CITY OF ALBUQUERQUE

**RE: Highland High School Title IX Gymnasium Upgrade-Phase 2, 4, 5 & 6
4700 Coal Ave SE
Requested Permanent C. O. – Accepted
Engineers Stamp Date 6/23/16 (K17D021)
Certification dated: 4-1-19**

Enclosed for your review is a copy of the above referenced project's Drainage Certification Submittal. This is the **Overall** As-Built Drainage Certification for the entirety of the Highland HS Title IX Gym Upgrades.

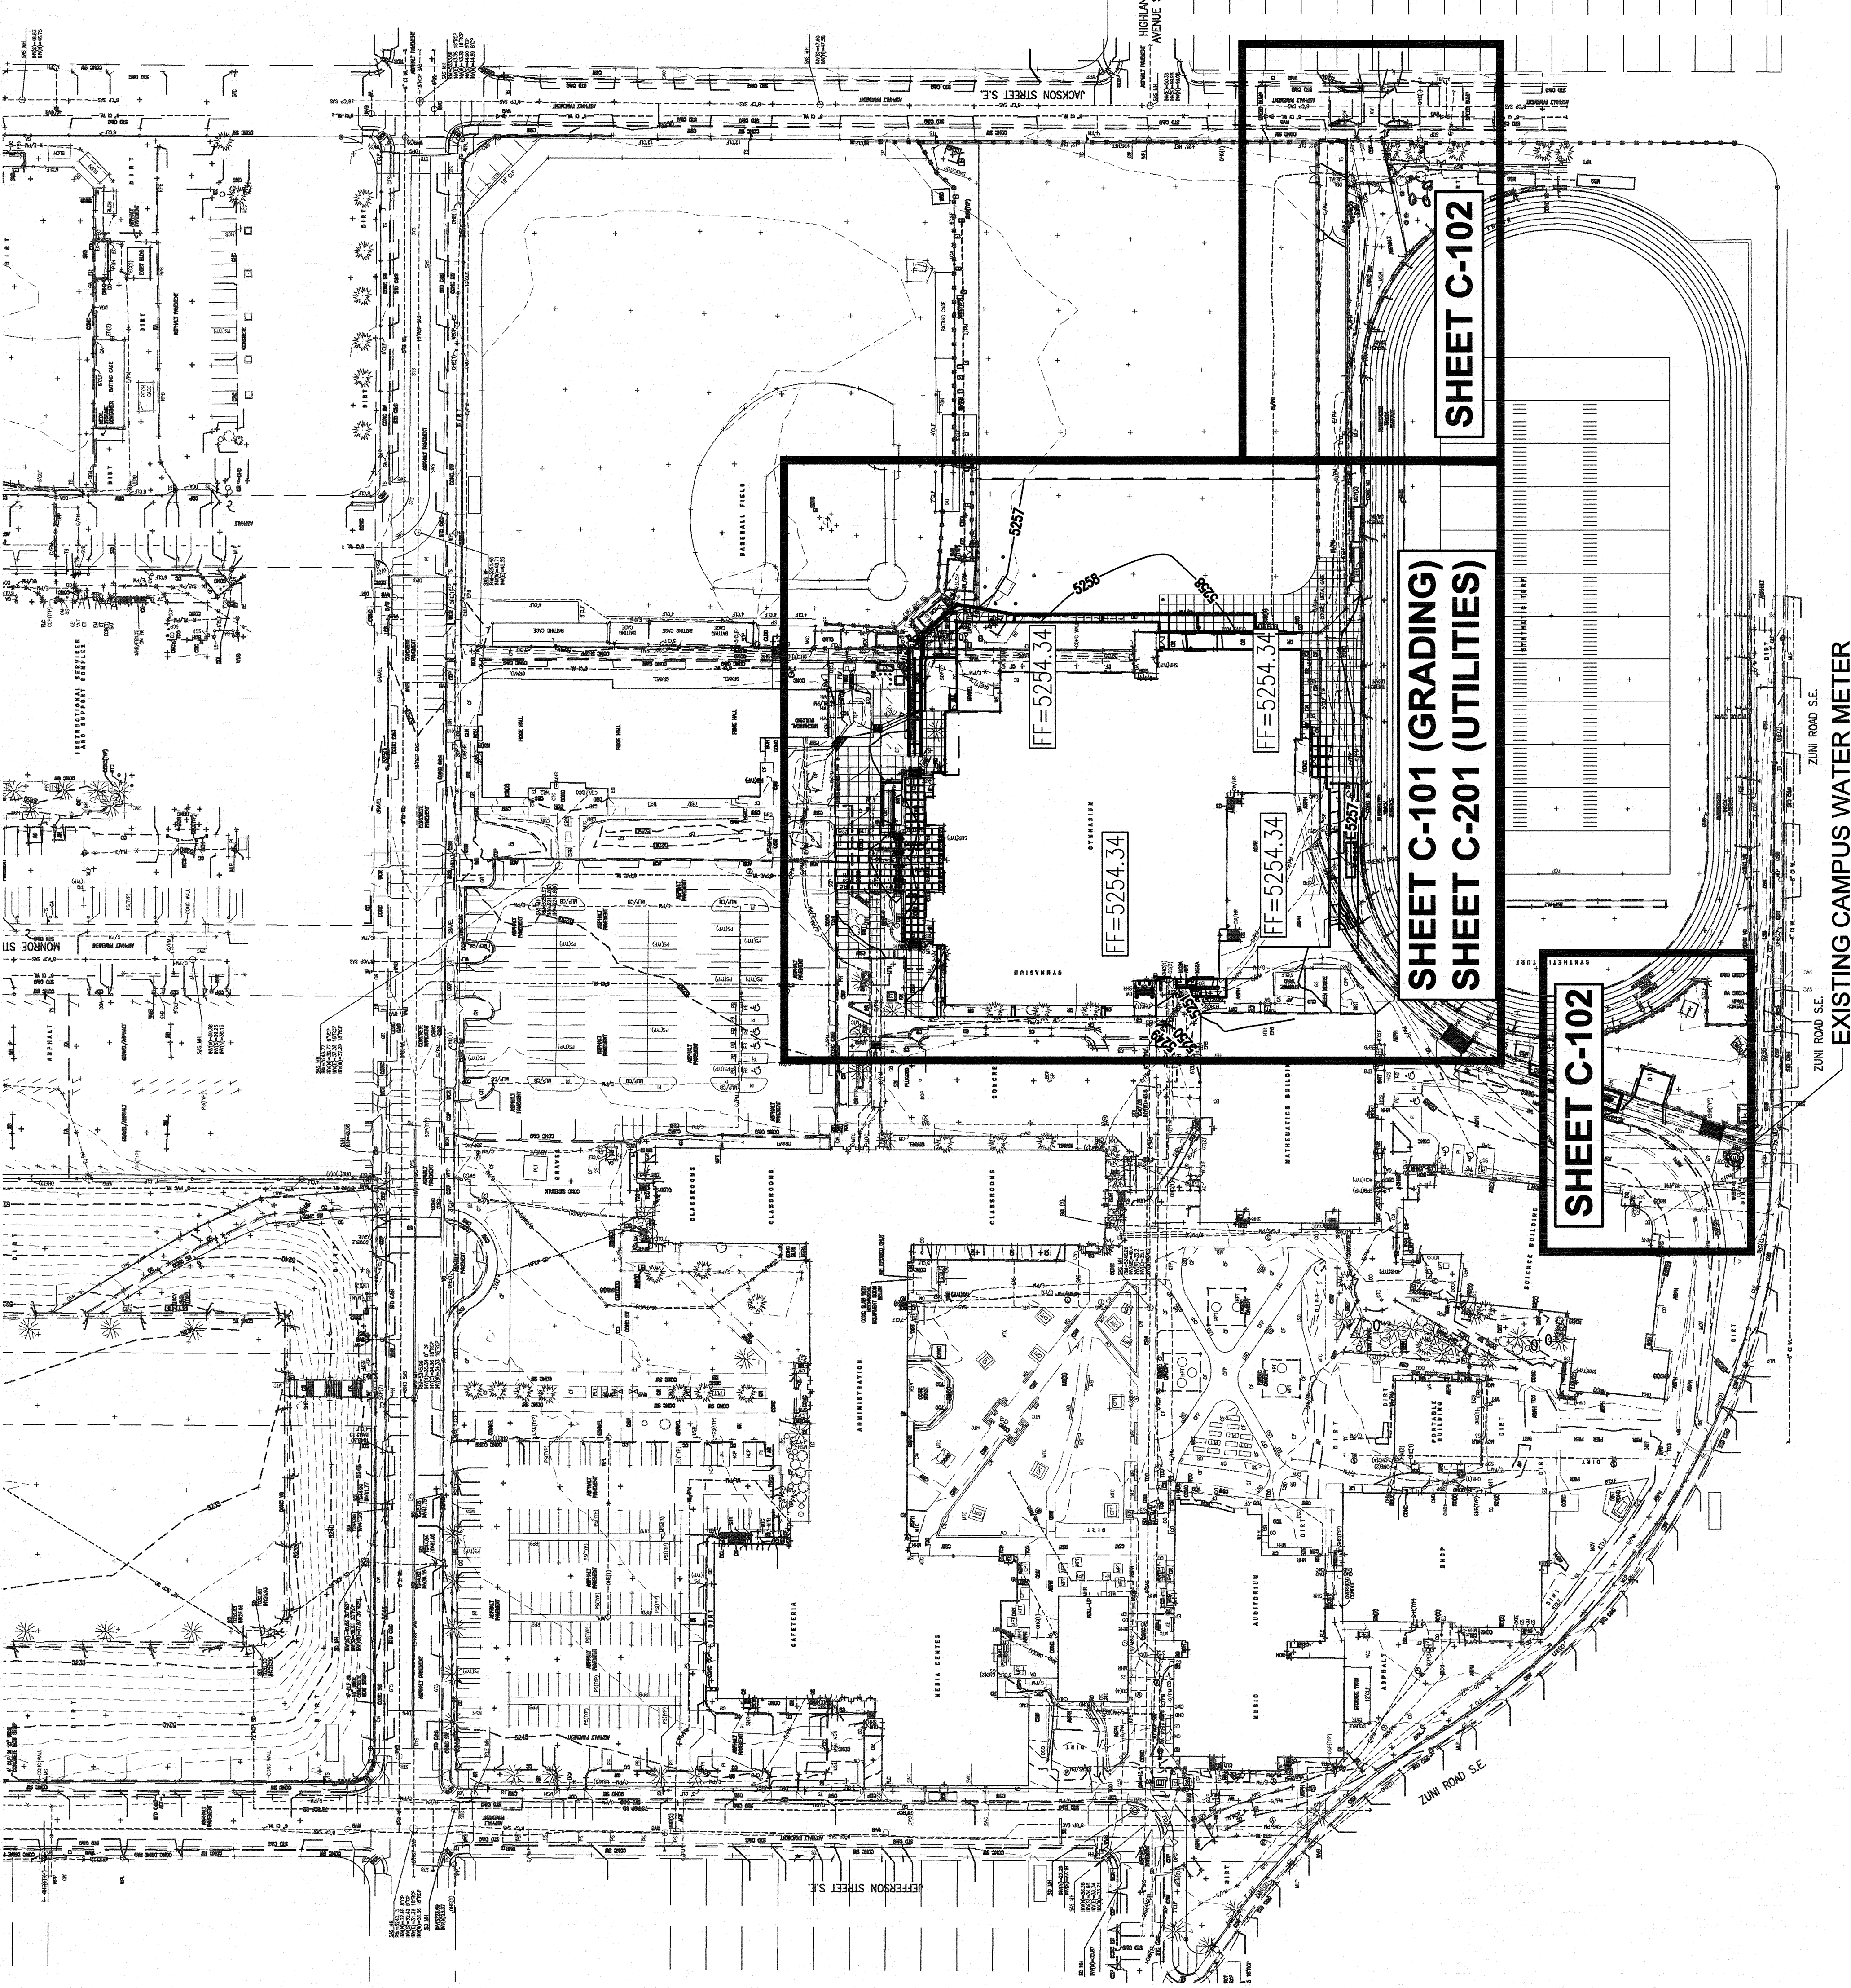
Before Phases 1 and 3 can be accepted for a permanent CO the following comments must be addressed.

- All construction fencing is to be removed from Phase 3. See attached pic.
- The roof drains need to be connected to the down spouts in Phase 3.
- Note 15- Clean existing trench drain clear of debris and ensure proper function.
- Plates on all sidewalk culverts need to be bolted down in Phase 1.

An inspection by our office will need to take place after these corrections are made.
